ADDENDUM NUMBER THREE JOHN MARTIN NATURE CENTER

Issued: 26 July 2024

RESPONSES TO RFI'S

LS1.0

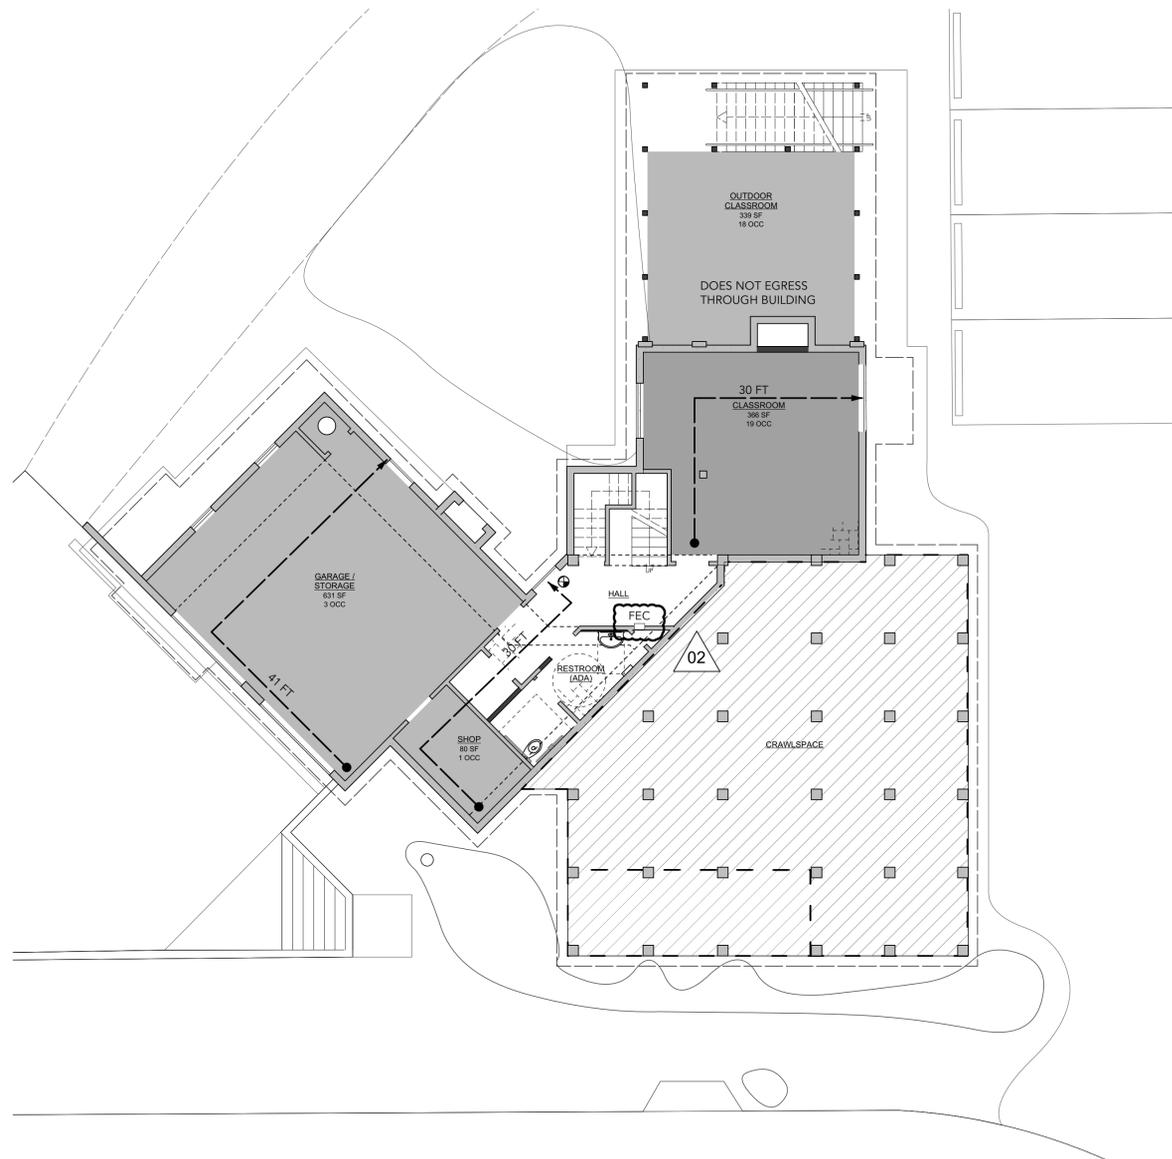
18. Will you also provide a count and location for Knox boxes and fire extinguisher cabinets?

- A SURFACE MOUNTED SECURE LOCK BOX SHALL BE PROVIDED NEAR THE MAIN ENTRY TO THE BUILDING. EXACT LOCATION TO BE DETERMINED IN FIELD BY OWNER.
 - PROVIDE 1 FIRE EXTINGUISHER PER FLOOR. LOCATIONS PROVIDED IN ATTACHED REVISED SHEET LS1.0 AND LS 1.1.

4. SEE ATTACHED FOR REVISED DRAWINGS TO SUPPORT RESPONSES TO RFIS ABOVE.
 - LS1.0 AND LS1.1:
 - i. SHOWING LOCATION OF FIRE EXTINGUISHER CABINETS ON LIFE SAFETY PLANS
 - A1.0:
 - i. REMOVED LANDSCAPE CONCEPT THAT IS NOT PART OF THE SCOPE OF THIS PROJECT FOR CLARITY.
 - ii. ADDED DIMENSIONS FOR BRIDGE EXTENTS.
 - iii. ADDED NOTES TO CLARIFY GRADING AWAY FROM BUILDING AND PARKING LOT
 - iv. REMOVED SWALE ON NORTH SIDE OF BUILDING

UPLIFT RESISTANCE DIAGRAM

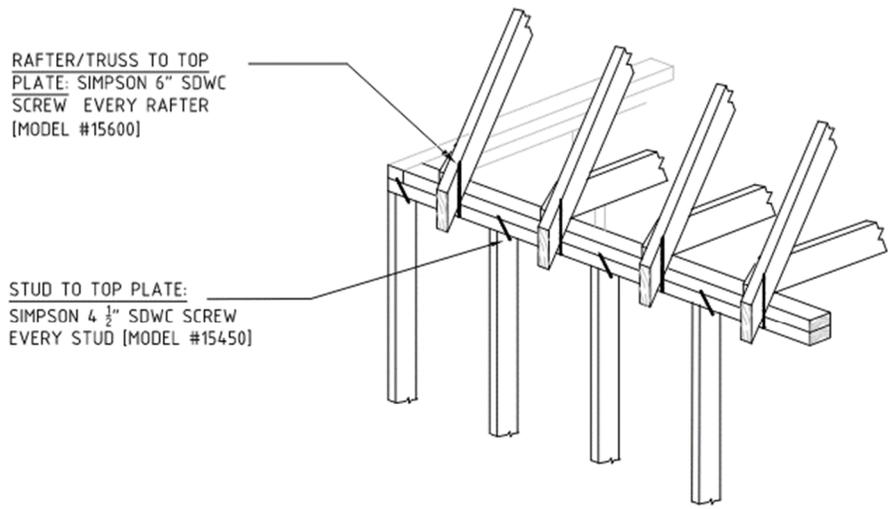
28. Will the contractor be required to do additional demolition in order to provide strapping at roof and foundation.
- SEE CLARIFICATION FROM STRUCTURAL ENGINEER.

We are submitting this letter to address the City of Fairhope's request to specify the uplift anchorage of the roof in response to the Level 3 designation assigned to the building. We conducted an inspection on July 17, 2024 to verify any existing connections. Mechanical hardware such as strapping and/or structural screws could not be found, which was expected due to the age of the structure. To ensure the ability of the roof to withstand design wind loads, the enclosed detail shows the recommended attachment of the rafters and studs.

The inspection also revealed that there were embedded threaded bolts protruding from the sill plate at the basement level foundation, but no nuts or washers to complete the holddown capacity. We recommend adding standard nuts sized to fit the existing bolts along with 3x3x1/4" washers to all of the foundation bolts to provide a connection that is capable of resisting uplift.
